STANDARDS AUSTRALIA

Amendment No. 1
to
AS 3775.1:2014
Chain slings for lifting purposes—Grade T(80) and V(100)
Part 1: Product specification

SUMMARY: This Amendment applies to the Preface, Clause 5.13.3, Figure 10 and Appendix D.

FIGURE 10 TYPICAL MARKING FOR TAG

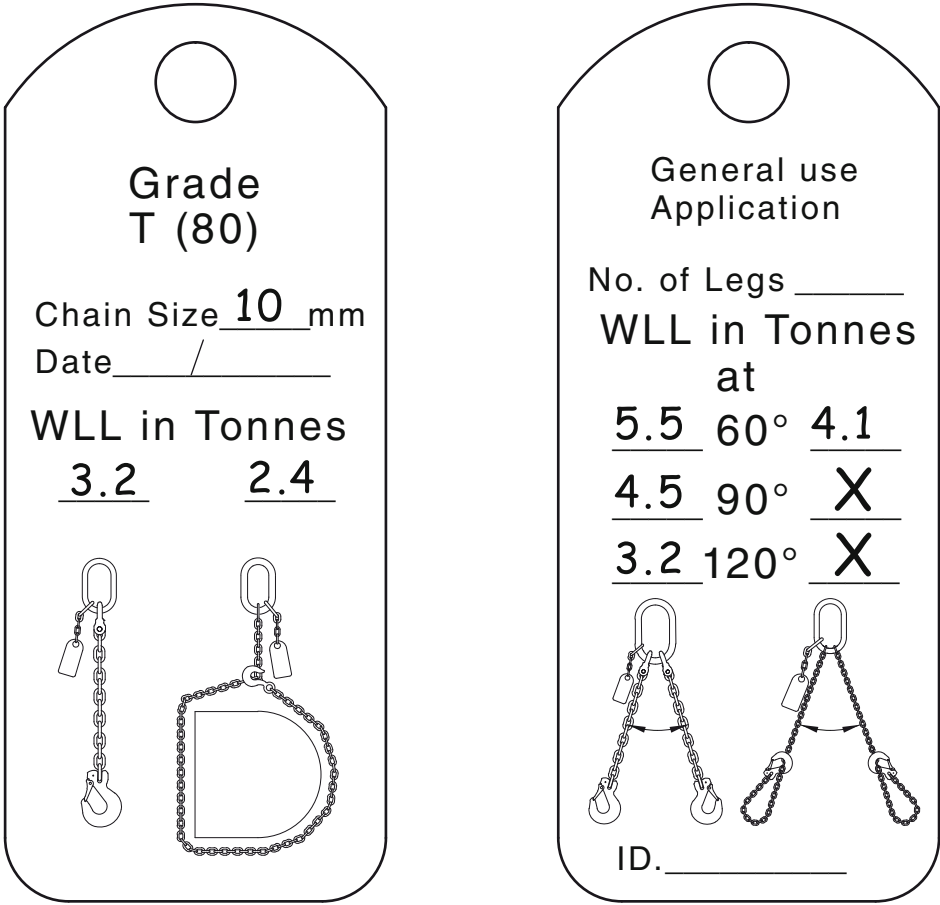
Delete Figure and replace with the following:
